Overview: Production error in version 1.0 harnesses; The immobilizer wire (orange/black) is in pin position #4 instead of pin position #5. Although an effort to correct the issue was made, some quantity of harnesses did get shipped before the issue was spotted. We are advising to inspect the harness BLADE connector before attempting to install harness or program the module. This issue is not known to affect the version 2 harnesses, which require no modification.

Overview: Early versions of the FTI-STP1 harness require modification for **automatic transmission (AT)** applications, some of the product was able to be modified before release, but a small quantity was released without modification.

FTI-STP1: Installation and Configuration Notes

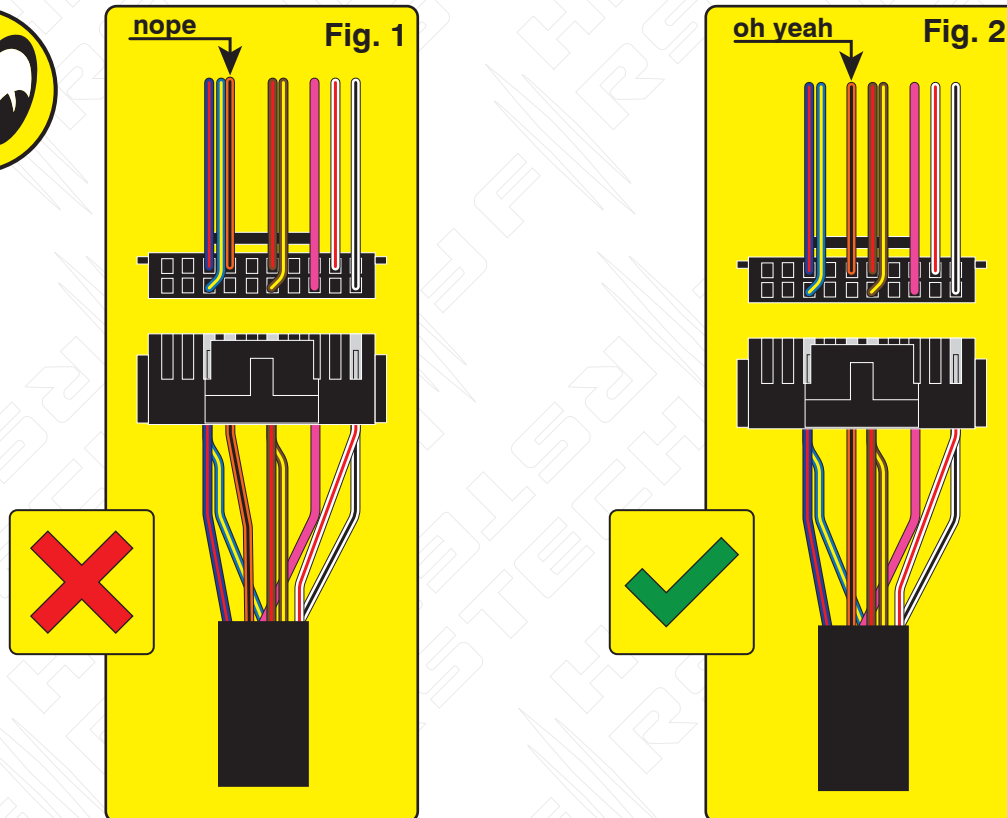
Issue: Module fails to program correctly to vehicle, does not allow the vehicle to be remote started.

Correction: Step 1.) Locate the orange/black wire and confirm whether it is positioned as illustrated in Fig. 1 or Fig. 2. If the wire is as illustrated in Fig.1, proceed with Step 2 through 5 and complete the repair procedure outlined, if the wire is as illustrated in Fig. 2, correction is not necessary, proceed with harness installation and module programming.

Step 2.) Using a pick, lightly depress the catch that secures the terminal in the housing then remove the wire and terminal from the housing.

Step 3.) Using a fine tip razor or utility knife, insert the blade beneath the terminal catch and raise it slightly, so that it can be reused to secure the terminal when reinserted into the BLADE connector housing.

Step 4.) Refer to Fig. 2 for correct position of the orange/black wire (next to brown/red) then reinsert the terminal, pressing lightly until the catch 'snaps' into place, securing the terminal in the connector housing.

MODIFICATION REQUIRED FOR A/T APPLICATIONS, ONLY WITH v 1.0 HARNESS

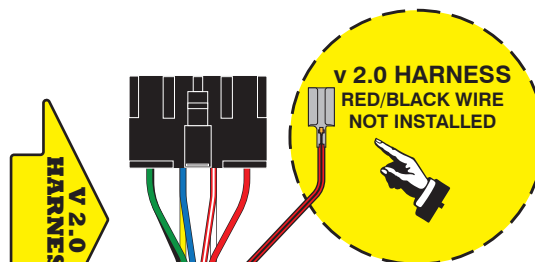
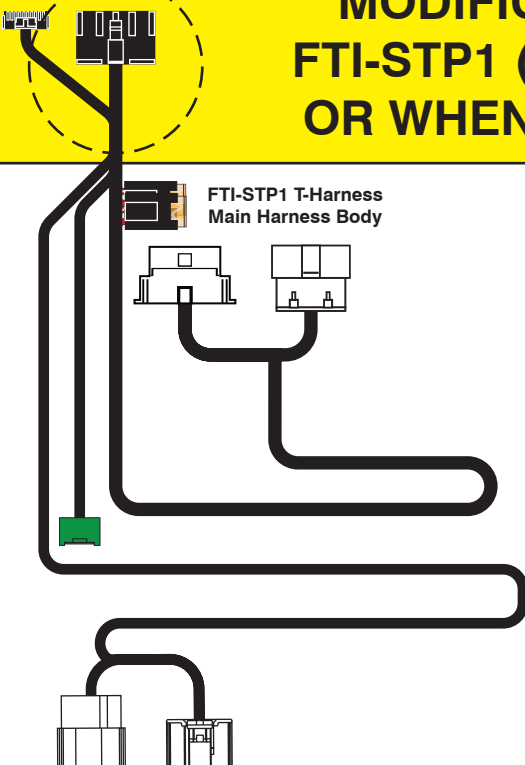
Issue: The FTI-STP1 T-harness has been designed to be compatible with A/T (automatic transmission) & M/T (manual transmission) applications, but due to an oversight in early production runs, the selection was defaulted to M/T mode.

Using a harness configured for an M/T application, in an A/T equipped vehicle, could result in vehicle module damage, it is advised that the harness be returned to A/T mode before installation in vehicles equipped with an automatic transmission.

Correction: Locate the **red/black (+ Clutch)** wire provided in the CN1 connector of the main harness assembly. Cut the **red/black** wire, either flush to the CN1 connector, or leaving enough wire exposed so that you can insulate and secure the ends of the wire that remain after cutting. Insulate each of the remaining ends of the **red/black** wire and secure to prevent any possibility of a short circuit. **If the red/black wire has already been disconnected, no further modification is required for A/T applications**

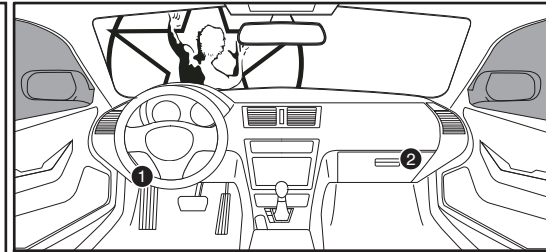
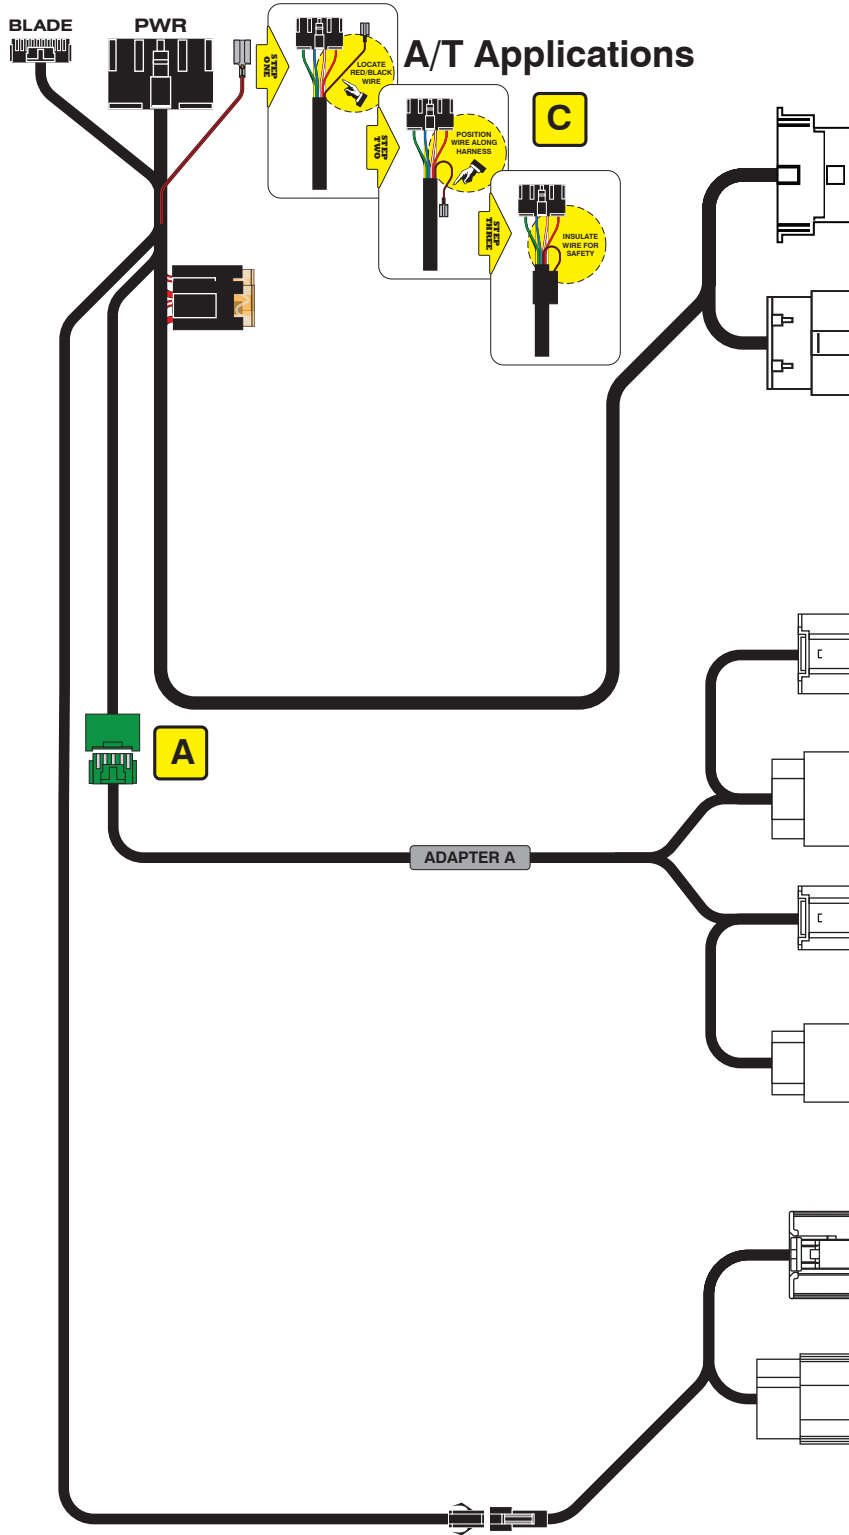
CMX, CM7, and CM9 Series controllers: No configuration changes required. *See previous page for modification required at the CN1 connector parking light (+ clutch) output position .*
